CITY OF CODY  
PLANNING, ZONING, AND ADJUSTMENT BOARD  
TUESDAY MAY 28, 2019  
CITY HALL COUNCIL CHAMBERS @ 12:00 NOON

**CITY OF CODY  
PLANNING, ZONING AND ADJUSTMENT BOARD  
STAFF REPORT**

<b>MEETING DATE:</b>	MAY 28, 2019	<b>TYPE OF ACTION NEEDED</b>	
<b>AGENDA ITEM:</b>		P&Z BOARD APPROVAL:	X
<b>SUBJECT:</b>	DOWNTOWN ARCHITECTURAL DISTRICT REVIEW: 1502 BECK AVE. SPR 2019-12	RECOMMENDATION TO COUNCIL:	
<b>PREPARED BY:</b>	TODD STOWELL, CITY PLANNER	DISCUSSION ONLY:

<b>MEETING DATE:</b>	MAY 28, 2019	<b>TYPE OF ACTION NEEDED</b>	
<b>AGENDA ITEM:</b>		P&Z BOARD APPROVAL:	
<b>SUBJECT:</b>	OVERFIELD MINOR SUBDIVISION PRELIMINARY PLAT. SUB 2019-06	RECOMMENDATION TO COUNCIL:	X
<b>PREPARED BY:</b>	TODD STOWELL, CITY PLANNER	DISCUSSION ONLY:

PHOTO RENDERING

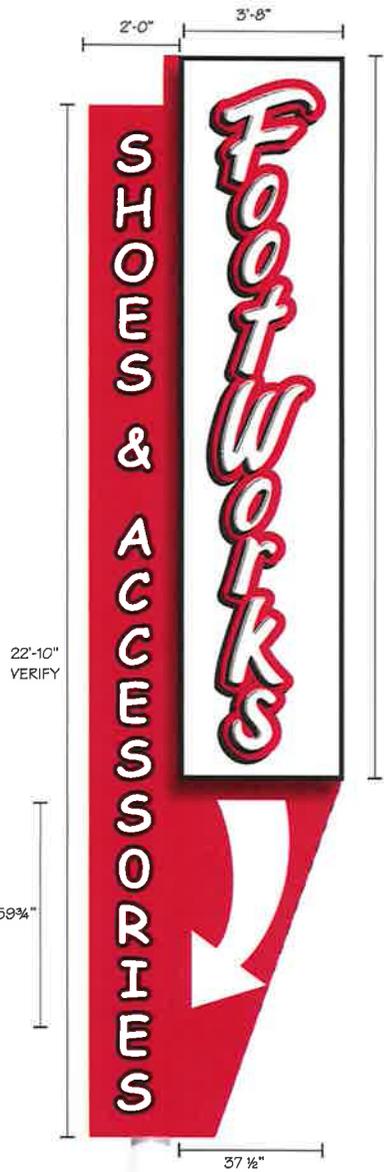
The Board approved the wall sign and freestanding sign for Footworks last month. However, the final design for the freestanding sign has been changed—see attached page. It is largely the same, except the entire panel will be illuminated—at the meeting the applicant explained that only the lettering would be illuminated. Staff believes the change requires Board review.

If the Board is agreeable, approve the modified freestanding sign as proposed.

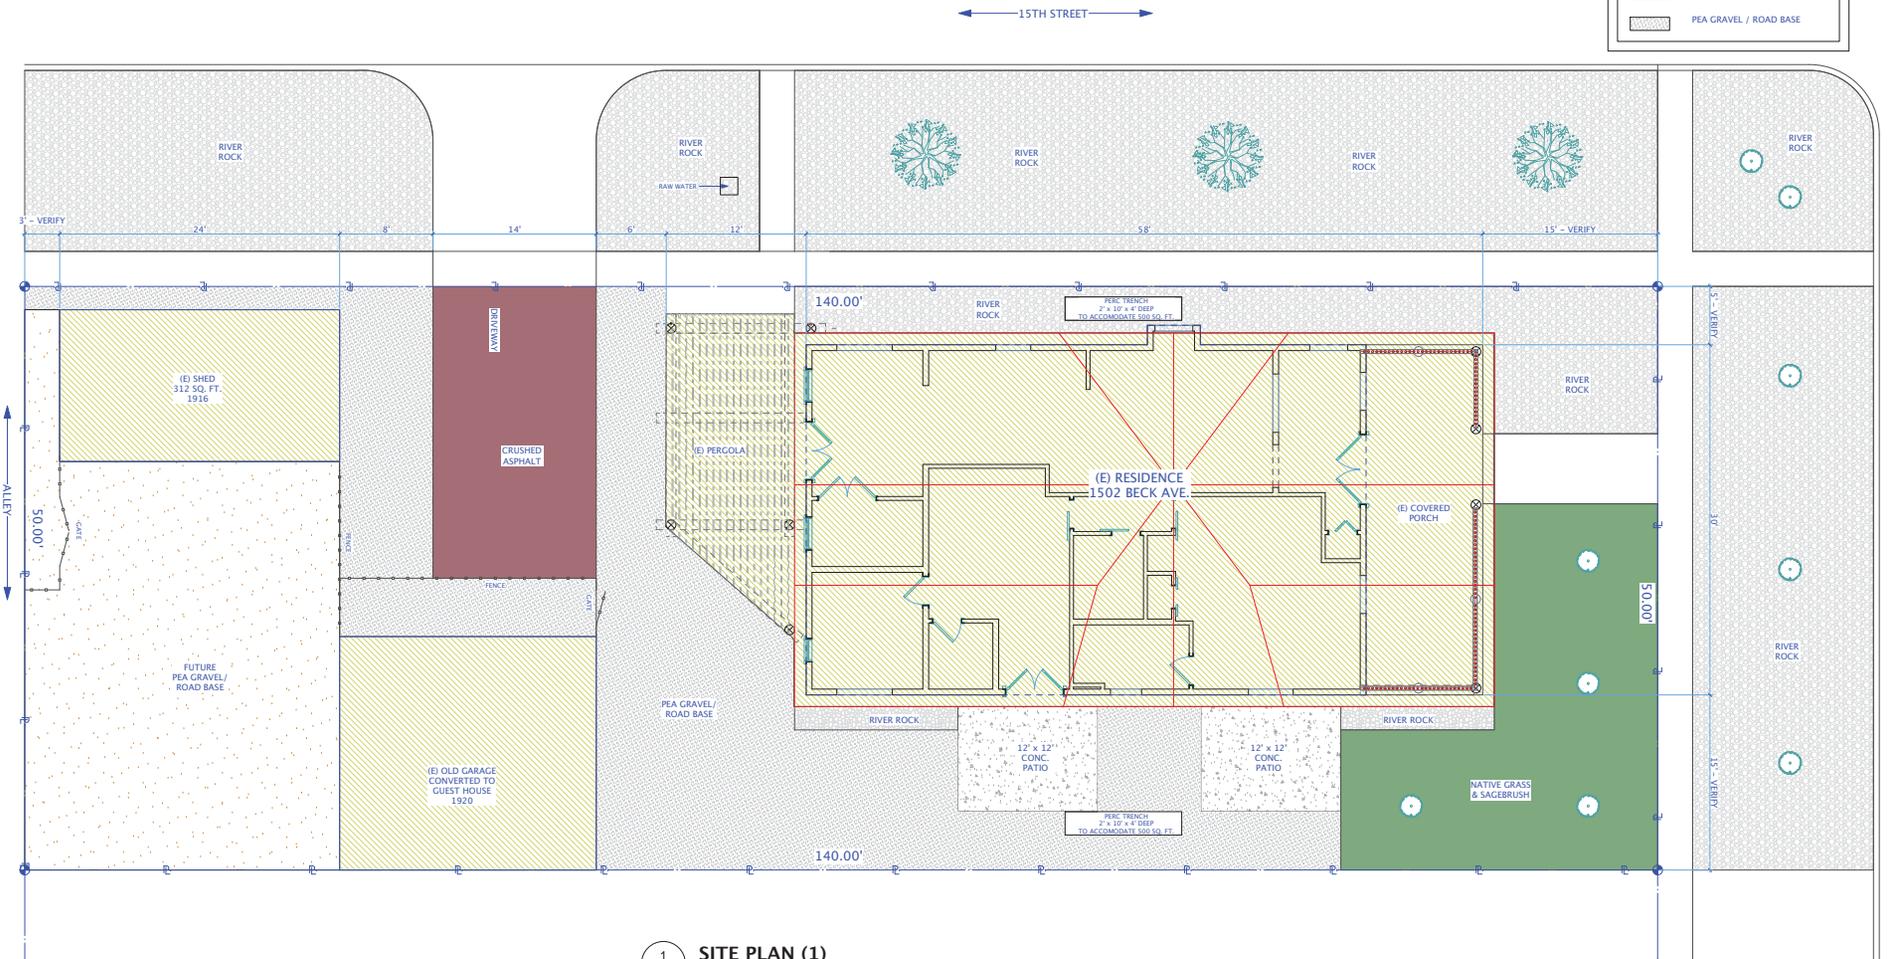
The property owner has utilized peeled logs where timber beams were indicated on the authorized plan. The pergola, which was not previously authorized, is also composed of peeled logs. The logs are not sealed at this point, as they need to dry and season first. The applicant plans to seal them as is to keep the natural color. The pergola meets applicable setbacks.

The Board will need to determine if the architecture of the pergola is architecturally compatible with the General Business (D-2) zoning district. Staff does not appreciate these after the fact reviews, as any significant change would involve reconstruction. Ideally, it would likely look better if the slope of the pergola were different—either matched the main building or sloped to the south. Other color options may help it and the woodwork on the front blend in better with the main building, which could be accomplished with staining, such as was depicted in the rendering for the front addition that was approved.

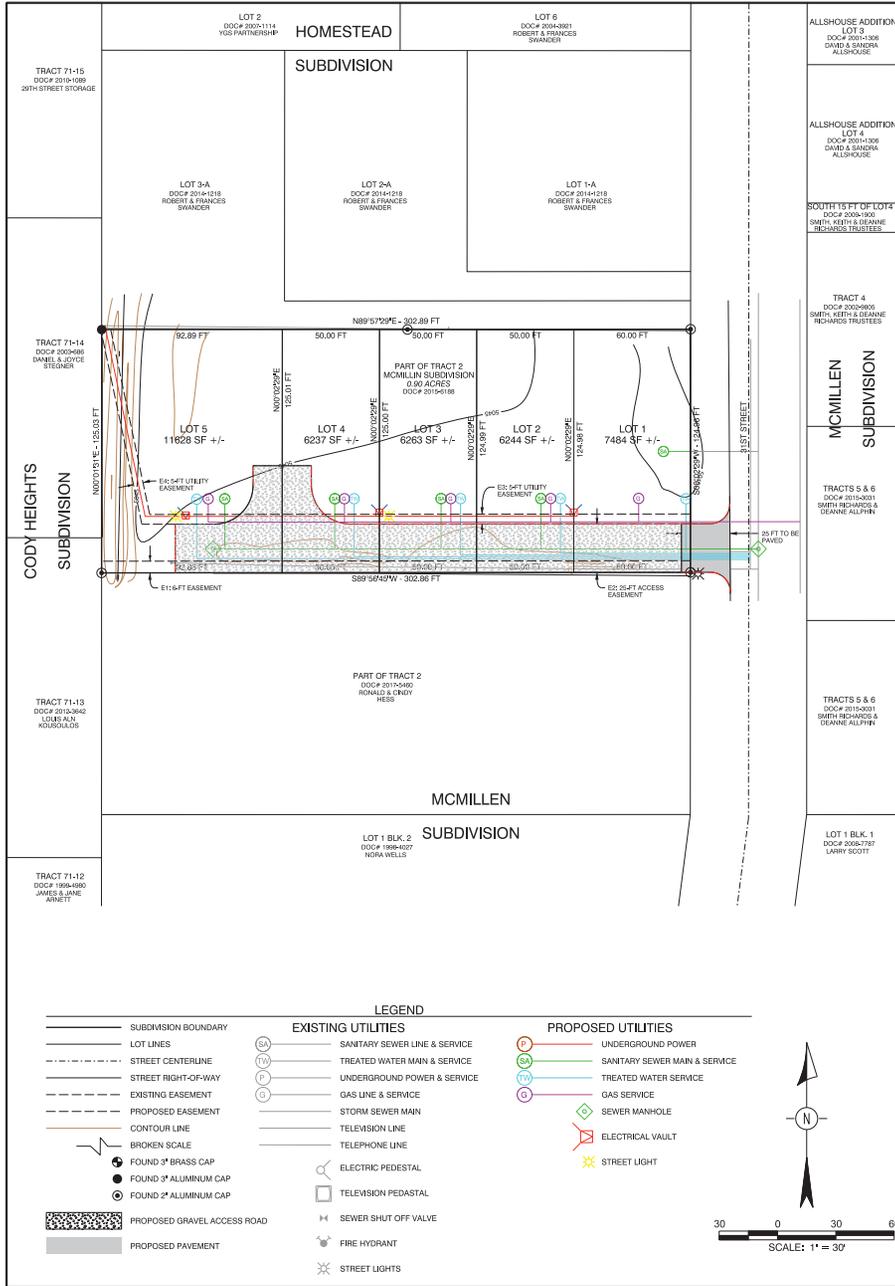
*Comment: Individual water lines are shown. However, the plan shows a single sewer line acting as a main for all five lots. The infill regulations were developed for straight-forward situations, which would not involve extensions of public sewer and water mains and the accompanying engineering and WY DEQ review and approval. The infill template does not authorize the use of private sewer mains. In addition, the use of the private sewer main would require a WY DEQ permit per their Policy 13.9.9, as it serves more than two buildings on separate lots, and therefore would need the necessary engineering, plan and profile drawings, and City authorization. Lastly, the sewer requirements in the subdivision ordinance lack any language that would indicate that sewer mains serving multiple lots can be private.*

*Comment: The preliminary plat indicates the minimum dimensions required, but lacks details on the base and top course specifications. It is suggested that the application include a cross-section of the road with the relevant construction details.*

*Comment: No cross-section is provided. The application indicates a 25-foot wide access easement with a 25-foot wide gravel access road. Only an 18-foot wide access road is required, and a few feet is needed for the drainage swale/infiltration trench and fence. The Board should require a cross section to note these details.*

*Comment: The turnaround meets dimensional requirements, except that it appears to have only 15-foot radii where 20-foot radii are required.*

*Comment: There are several construction details relating to the utility requirements of this section that are not reflected in the application (e.g. individual sewer lines, cleanouts with concrete collars, tracer tape above lines, marking posts, curb stops at edge of 31<sup>st</sup> Street right-of-way). Rather than noting all of them here, it is sufficient to say that additional detail is needed to demonstrate that the construction requirements of this section will be applied.*

*Comment: The application refers to a cross section, but none was submitted. There is a note that the road will be graded to the north. This will mean that the standard stormwater detail in the template will not be adequate due to the driveways into the lots preventing construction of much of the length of the swale, so a revised configuration/sizing will need to be presented.*

*Comment: The application notes an existing 4-foot tall fence. The required 6-foot solid fence will need to be provided.*

Recommend that City Council approve the preliminary plat for the William & Rita Overfield Minor Subdivision, subject to submittal of the final plat and construction drawings with the following additions/clarifications:

1. Include a note that the subdivision improvements were based on the property containing no more one dwelling unit per lot. Additional dwelling units would require additional subdivision improvements.
2. Include the improvement district language for 31<sup>st</sup> Street in the Owner's dedication on the final plat.
3. Provide a maintenance agreement or covenants to set forth the maintenance responsibilities for the private access drive, including maintenance of the access drive, fence, and stormwater facility. See 11-8-5(C).
4. Provide approval of the Cody Canal and McMillin Ditch Company for the plan to pipe the McMillin Ditch.
5. Submit verification that the transfer of water rights from the property has been completed, or that the agreements and documents are in place to complete the transfer.

6. Applicable utility fees will need to be paid before the final plat is recorded (water tap fees and electrical materials estimate).
7. Include all construction details found in 11-8-4 on the plans either by drawing or note. Also include the mailbox location approved by the Post Office. The plans must reflect individual sewer services connecting to the main in 31<sup>st</sup> Street, and provide 20-foot radii on the turnaround.
8. The final plat application must be submitted within one year and otherwise comply with provisions of the subdivision ordinance.

**PRELIMINARY PLAT** SHEET 1/2

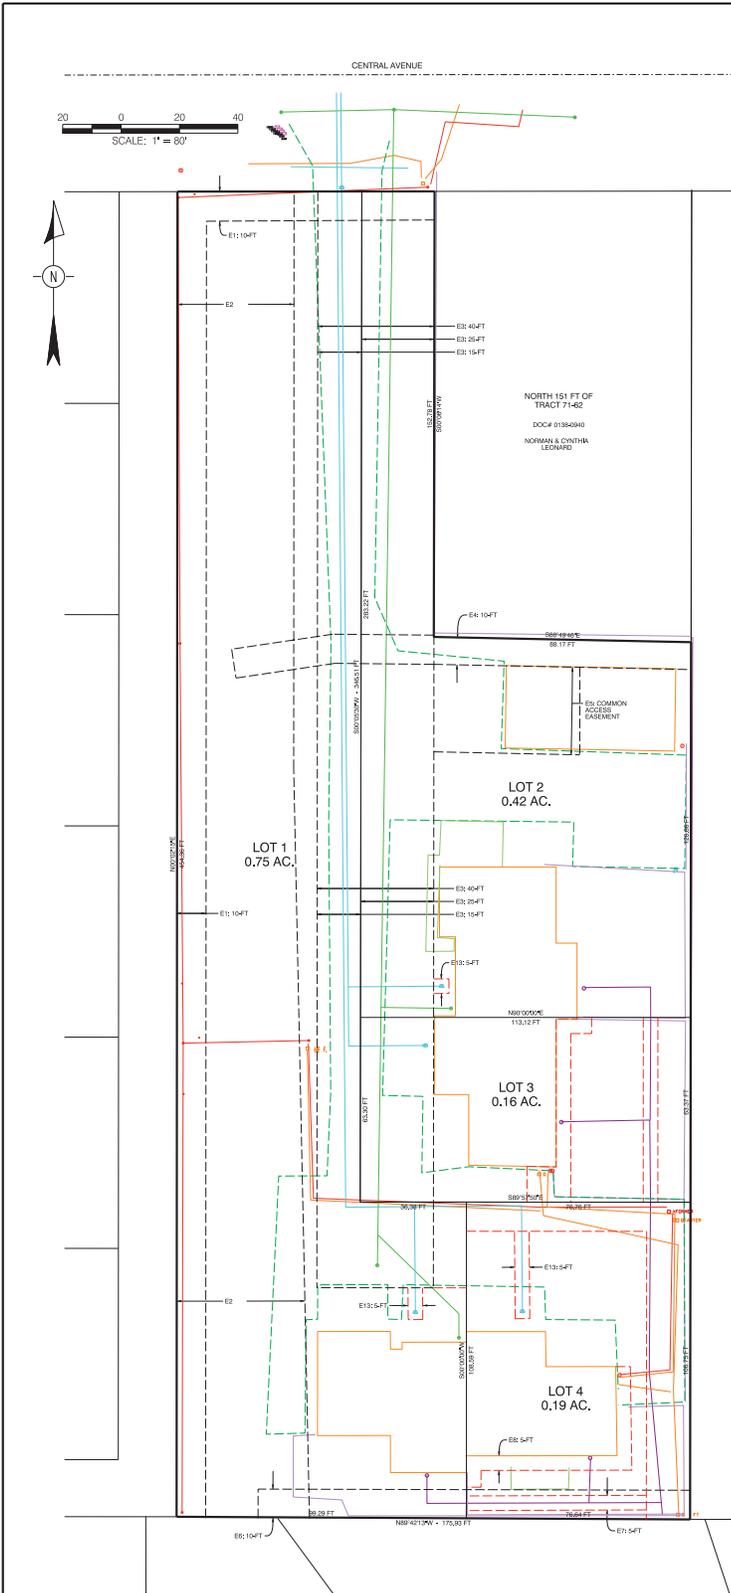
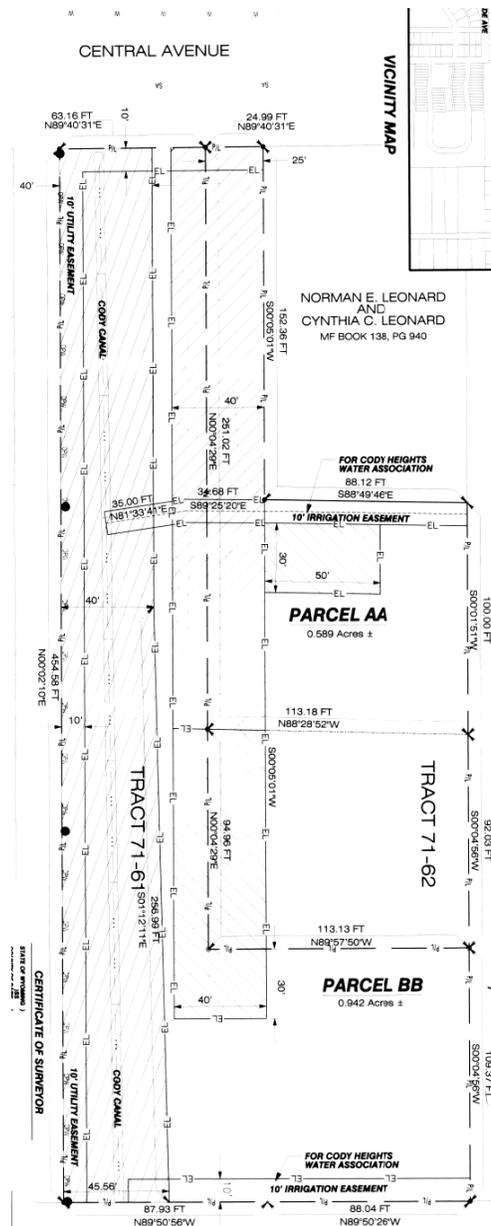
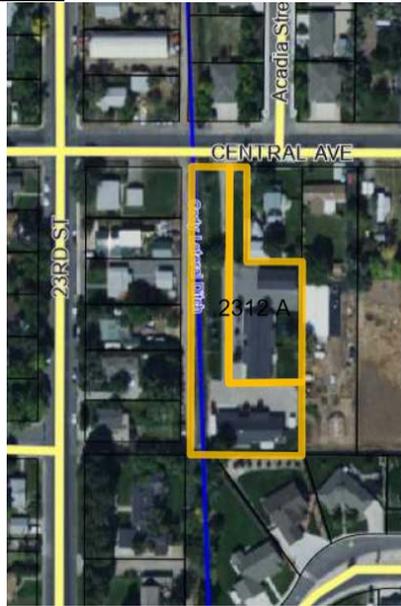
*Comment: The water lines are in blue on Sheet 1. Lots 2 and 3 share a water line and Lots 1 and 4 share a water line.*

*The sewer lines are shown in green on Sheet 1. Again, Lots 2 and 3 share a sewer line and Lots 1 and 4 share a sewer line. The infill regulations were developed for straight-forward situations, which would not involve extensions of public sewer and water mains and the accompanying engineering and WY DEQ review and approval. The infill template does not authorize the use of private sewer or water mains. In addition, the use of the private sewer main would require a WY DEQ permit per their Policy 13.9.9, as it serves more than two buildings on separate lots, and therefore would need the necessary engineering, plan and profile drawings, and City authorization. Lastly, the sewer requirements in the subdivision ordinance lack any language that would indicate that sewer mains serving multiple lots can be private. The City water regulations are specifically clear that water service lines cannot be shared between buildings. Section 8-2-20, reads, "NEW WORK: The water piping system of each new building and of new work installed in an existing building shall be separate and independent of that of any other building. All piping or plumbing installed by the owner shall comply with the requirements of this chapter and the plumbing code as adopted by the city."*

*Comment: The table indicates a minimum 18-foot wide gravel road and a turnaround to be provided. The application indicates that the existing road is typically at least that width, but staff measurements reveal that the north segment of the road is only 15 feet wide. Widening all segments to at least 18 feet is required. Due to utility requirements, some of the roadway may need to be reestablished after utility*

*Comment: A turnaround is indicated near the middle of the access drive. The surveyor indicates that a full-sized turnaround cannot fit at the end of the access drive due to existing improvements. The Fire Marshal was contacted and he is agreeable to an exception to allow the turnaround where proposed. The Board can recommend a variance to this standard if agreeable.*

*Two sewer services, extending from the main in Central Avenue will need to be added, so that each lot has its own line. Cleanouts will need to be installed in the new lines, spaced not more than 100 feet apart. Cleanouts should exist in the existing sewer lines—if they don't, they were not installed to code and further discussion is needed. All cleanouts in driving areas must be provided with concrete collars.*

*Electrical services will need modified, so that each lot has its own service all the way from the transformer (application shows spitting at electrical panels on duplexes, not at transformer)—coordinate with the electric division as there may be two ways of accomplishing this. The transformer is located at the NE corner of Lot 4.*

*Comment: There appears to be sufficient grass areas to each side of the drive that additional storm water facilities (i.e. swales) are largely unnecessary, except next to the Leonard property and to correct the ponding issue on the east side of the access drive next to the unit on Lot 2. A small swale along the Leonard property and draining the ponding area to the west side of the road should be adequate.*

*Comment: The fence requirement is applicable where the access drive runs along the Leonard property in the northeast corner of the subdivision. The neighbor already has a 6-foot cedar fence, but it appears to be towards the end of its useful life. The requirement is that the subdivider provide a fence on the property being subdivided. Anything else requires a waiver from the neighboring property owner and the Board.*

In most instances, staff lists conditions to address any outstanding issues; however, in this case, there are enough utility and irrigation details that need worked out that it is recommended that the Board confirm the conditions, timing and direction discussed in the staff report and table the application to allow the applicant to address those items and submit an updated plan for Board review.
